Paper No. 6223

The design and construction of the Hindiya Bridge †
by
John Francis Causton Swansbourne, A.M.I.C.E.

Discussion

FIG. 21.—SECTION THROUGH CROSS-BEAM AND SPLINE WALL

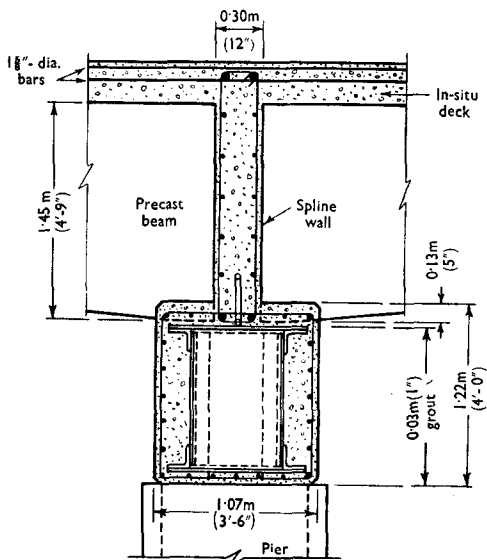
Mr Francis Walley (Senior Structural Engineer, Ministry of Works) referred to the concrete spans. In § 9 they were stated to be "continuous and monolithic with the piers and the abutments." Presumably this meant that they were designed as continuous beams over the piers and not that they were continuous and monolithic with the piers. If they were designed as continuous beams, were they designed as carrying the super-load only or the super-load and part of the decking? It was stated that 16-ft lengths of decking were cast over the piers, presumably to make the beams continuous at an early stage. If they were continuous, it would be interesting to see a detail, because there did not appear to be any way in which the compressive stress was transferred from beam to beam. It was not clear from the slides whether or not any steel had been taken through. If they were continuous, how was the tension steel taken over the support? It was the support which really transferred all the stress across, and no detail had been given of that important part.

61. In § 9 it was stated that "Figs 2 to 7 indicated the main principles of the design and the following points may clarify some of the detail." They did not appear to do so. The first statement made was "The five spans at each end of the bridge are continuous and monolithic with the piers and the abutments." The next relevant statement was that "Expansion of each group of side spans is taken up on rollers at each of the centre piers." Those two statements, he submitted, were mutually contradictory. If indeed the beams were continuous and monolithic with the piers, then the piers seemed stiff enough for the beams to be designed as virtually fixed-ended beams. If they were merely continuous, and not monolithic with the piers, it was difficult to understand the detail in Fig. 6, which certainly seemed to indicate that the whole was quite solidly fixed down. If it was fixed down, then although Mr Walley had said that the expansion movement must take place in the piers, Mr Goldstein did not see how that could be so without inducing appreciable temperature stresses. Since the piers were stiff, any expansion could not be taken by a rocking movement of the pier, but only by a bending movement, and, owing to the fixity at haunch level, there could be quite large bending stresses caused in the beam by temperature movement. Perhaps the temperature stresses had been allowed for. If so, what were they?

129. The articulation of the beam and pier system was questioned in §§ 55 and 61. Fig. 21 showed a section through the joint. The beams were continuous over the piers by tension steel in the deck and by concrete in compression in their soffits, which were carried through the thin spline walls surmounting the transverse box-girders. There was no compression steel. The spline walls were attached to the transverse girders with nominal reinforcement. Although the system appeared virtually monolithic the

attachment of the beams and spline walls to the tops of the box-girders could actually be considered as a pin joint with certain minor limitations. In the Author's opinion it was justifiably assumed by the designers that a hinge would form at the bottom of the spline wall by a slight horizontal crack between the soffit of the beam and the transverse girder on the one side and a slight plastic yield due to compression in the same place on the other side. With the formation of this hinge and the inherent flexibility of the pier as a cantilever almost no resistance was offered to temperature movement in the bridge, and consequently the temperature stresses would be very small.

FIG. 22.—EXPANSION OF DECK

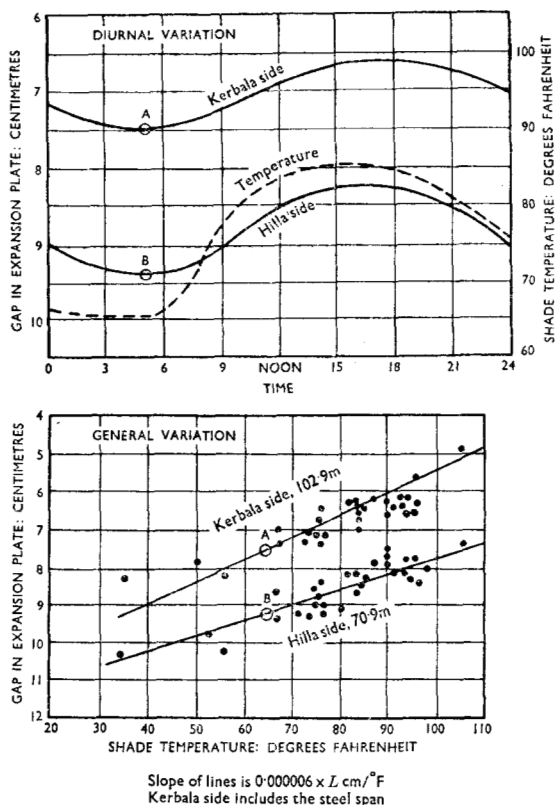
91. In the Hindiya Bridge the number of expansion joints had been kept to the minimum by making the deck continuous over the intermediate piers. Those piers were fairly flexible, but in cases where piers were stiffer the temperature movements on the concrete deck were an embarrassment. It was stated in § 10 that "Thermal movements in the concrete bridge deck were subsequently recorded over a period of 6 months from summer to winter and, with respect to variation of ambient air temperature, they conformed closely to customary calculation with a coefficient of 0.000006." Mr Austin had heard of many different customary methods of calculation; would the Author amplify that statement? Did the Author mean that the concrete deck reached the maximum temperature during the day or merely the average daily temperature during

the summer and the average daily temperature during the winter? The sections were very thin. In the case of thicker reinforced concrete sections it was often the practice to assume that concrete sections never suffered the full variation of air temperature.

152. Mr Austin had referred to thermal movements. The Author had meant that the bridge responded closely to all changes in ambient temperature. If the temperature rose 20°F between morning and afternoon then the bridge extended by $20 \times L \times 0.000006$. The higher temperature of the deck surface from direct sunlight presumably balanced out the cooler temperatures within the body of the deck and girders. Fig. 22 indicated the diurnal and general variations encountered. The divergence of points from the line on the second graph might be partly due to the lagging effect when readings were taken on a rising and a setting sun. The temperature of the concrete had never been taken. All measurements were compared with shade temperature.
